SECTION 009113 – ADDENDUM ONE

- A. Project Name: 22034.02 Meridian High School Additions, Renovations and Ballfield Rebid
- B. Owner: Meridian Public School District, 1019 25th Avenue, Meridian, MS 38391
- C. Architect: Dale | Bailey, an Association, One Jackson Place, Suite 250, 188 East Capitol Street, Jackson, MS 39201-2100
- D. Architect Project Number: 22034.02
- E. Date of Addendum One: 5 January 2024

1.4 REVISIONS TO DRAWINGS

S-101c

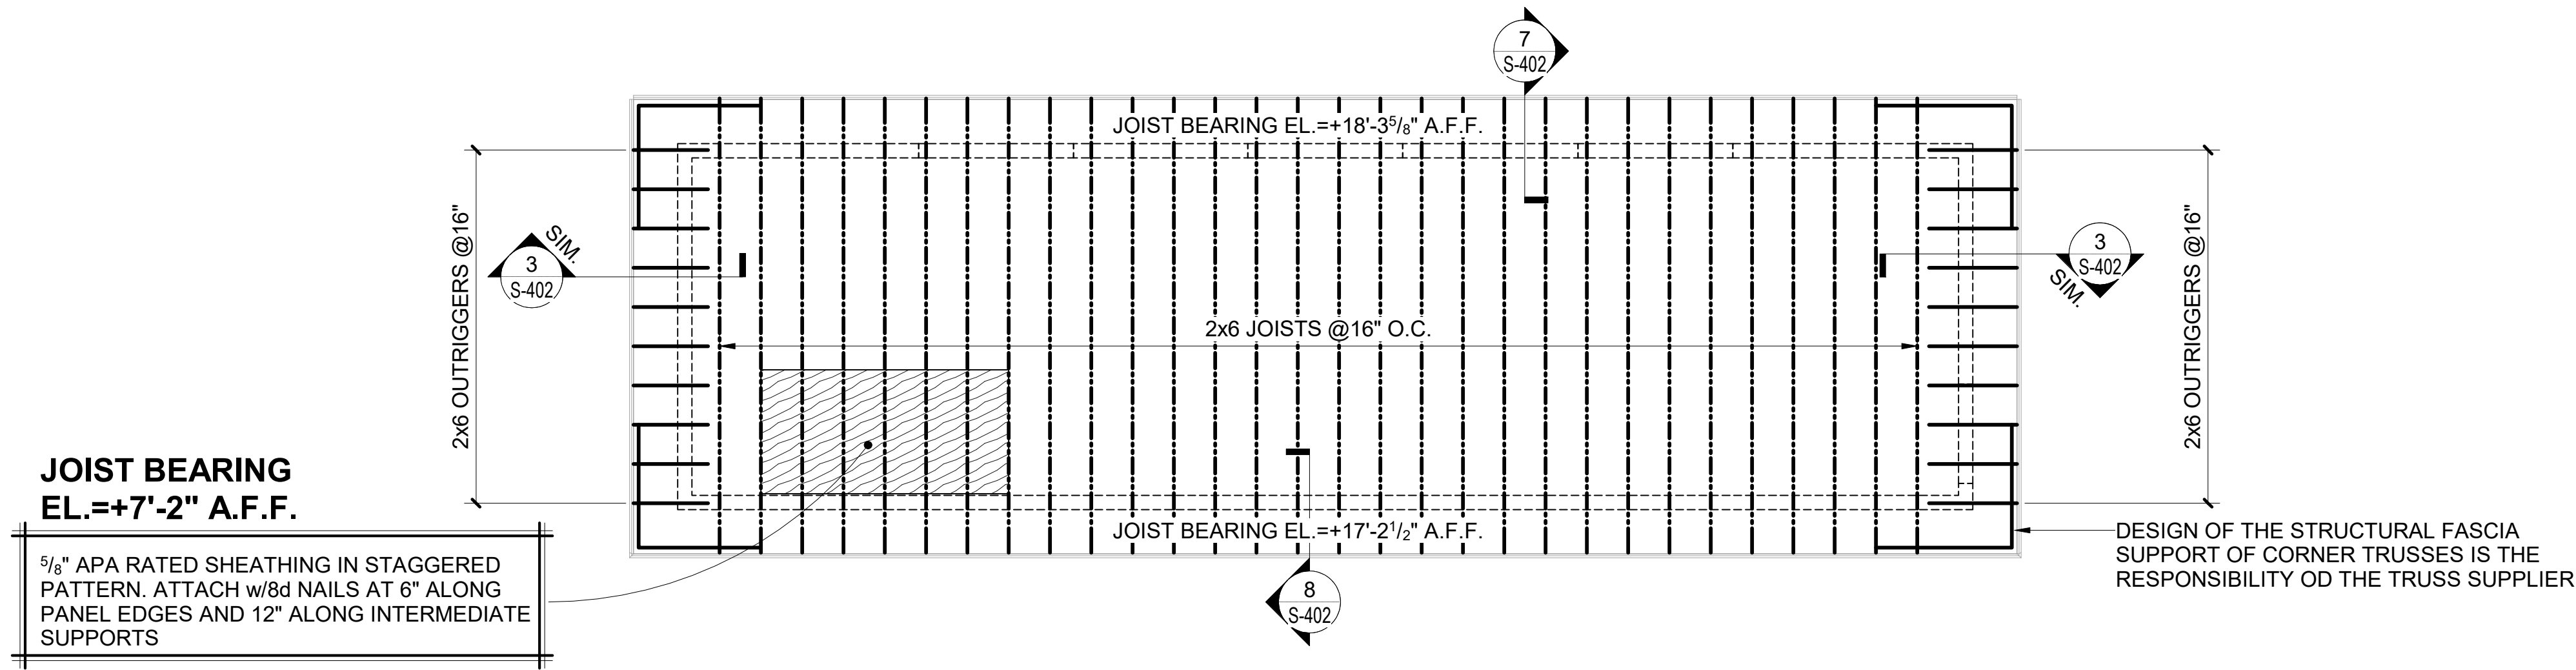
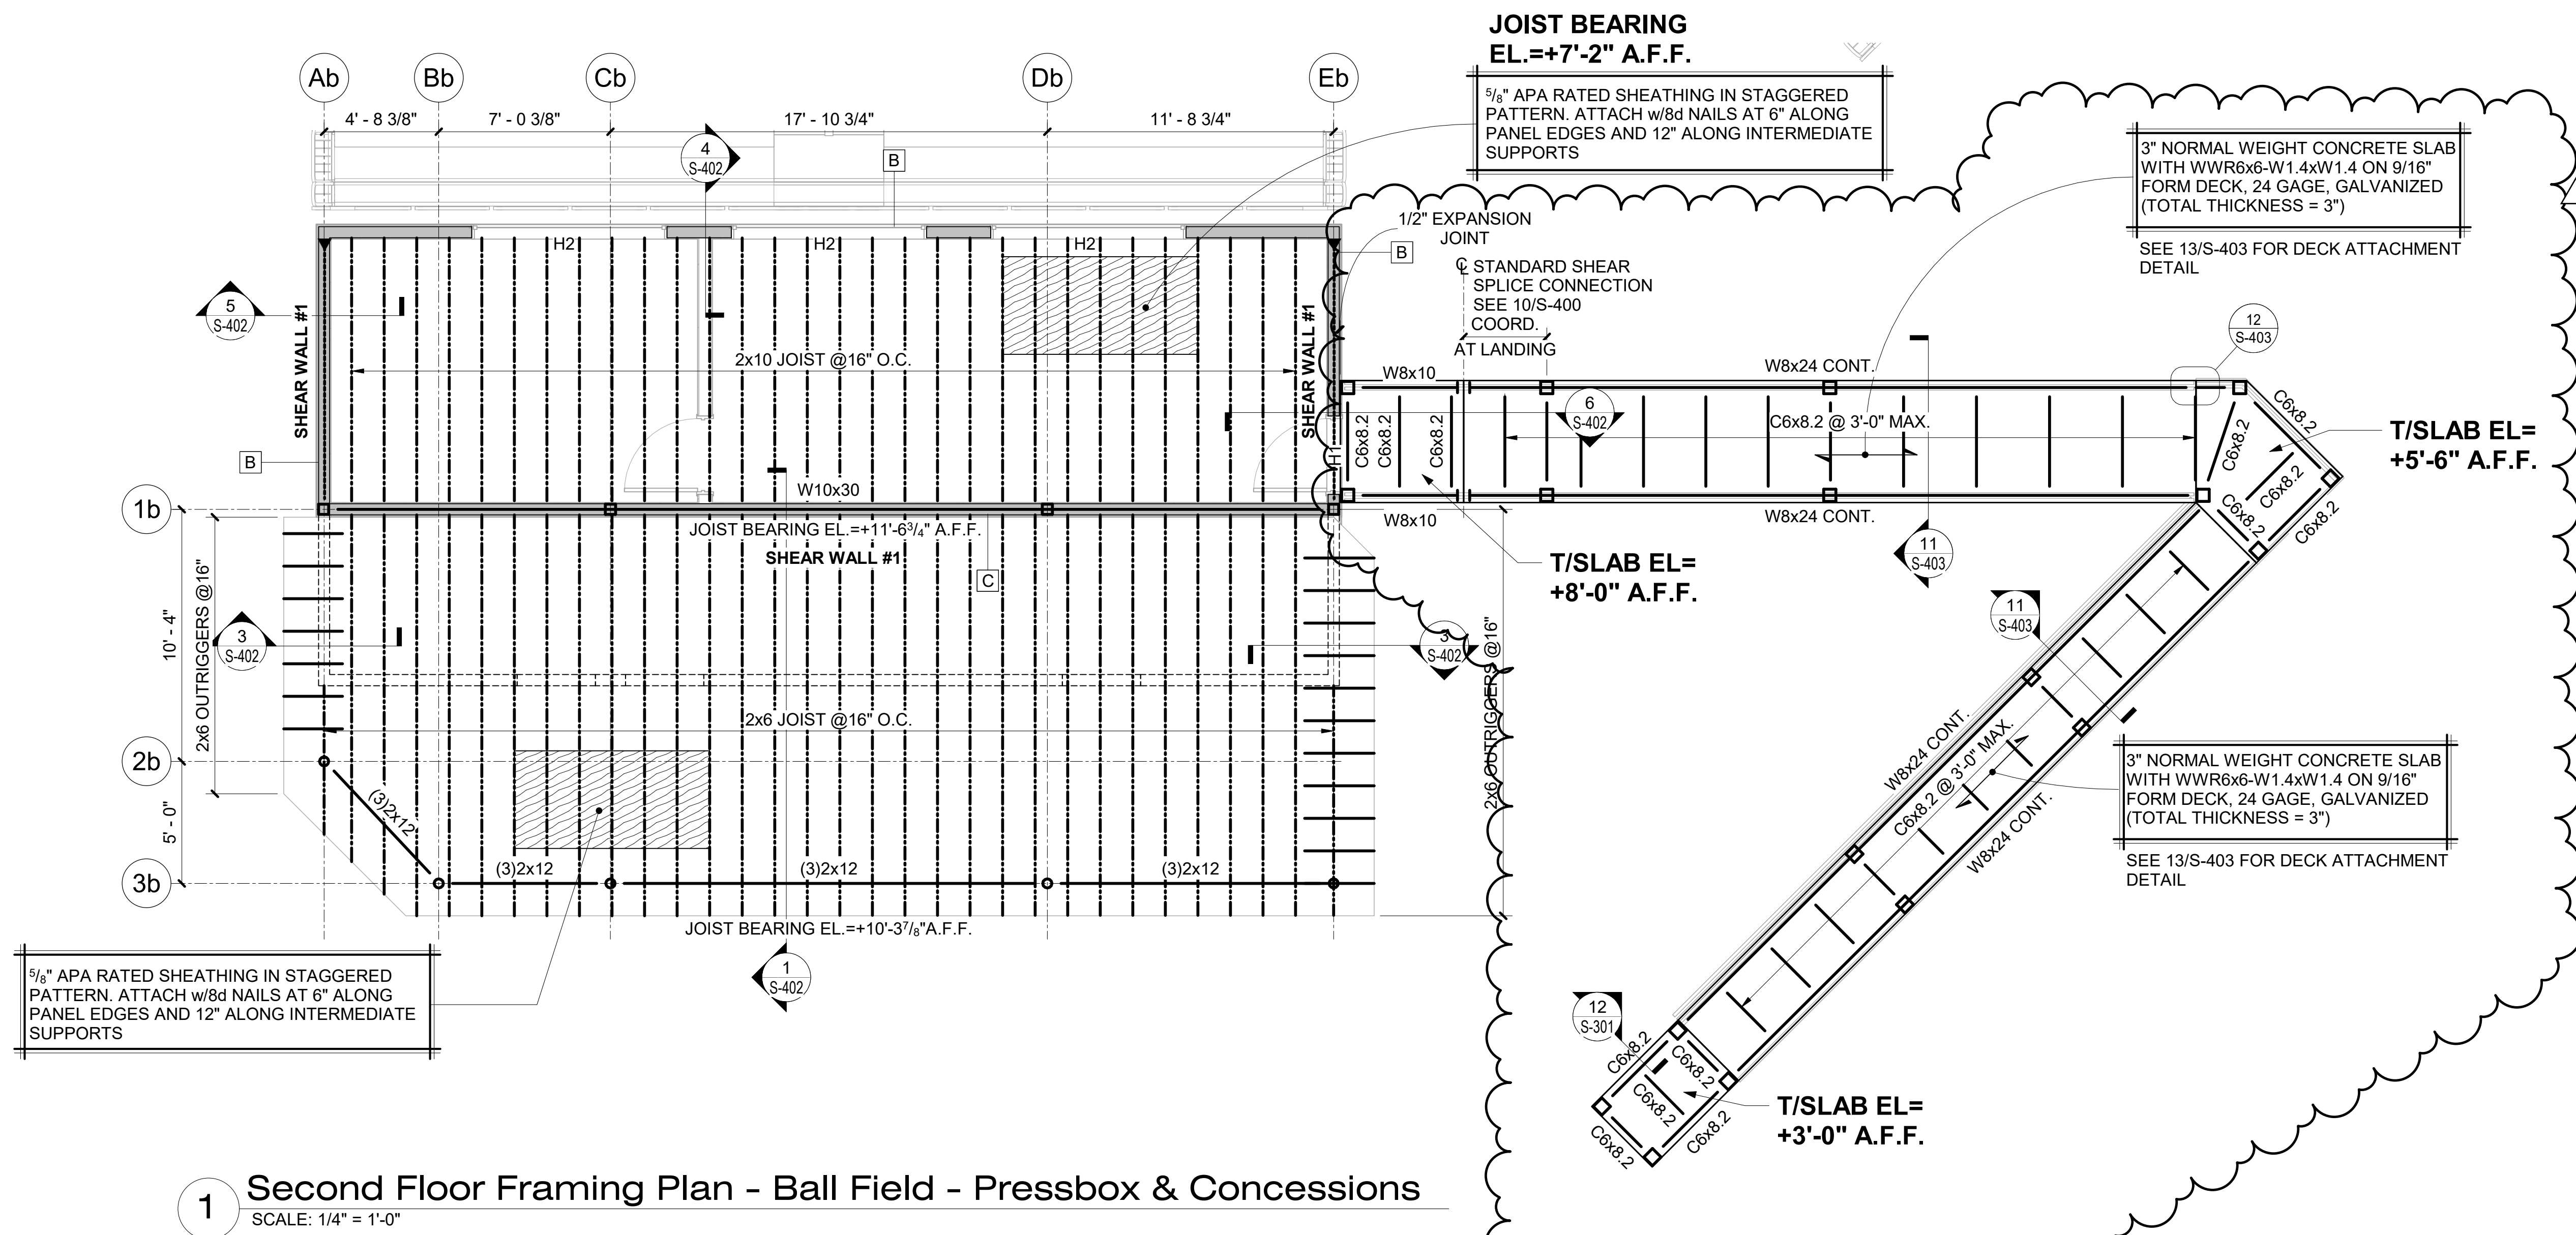
- A. Sheet S-101b (Revised). Pressbox foundation plan to include ramp columns and footings
- B. Sheet S-101c (New). Pressbox floor framing plan to include steel for entry ramp
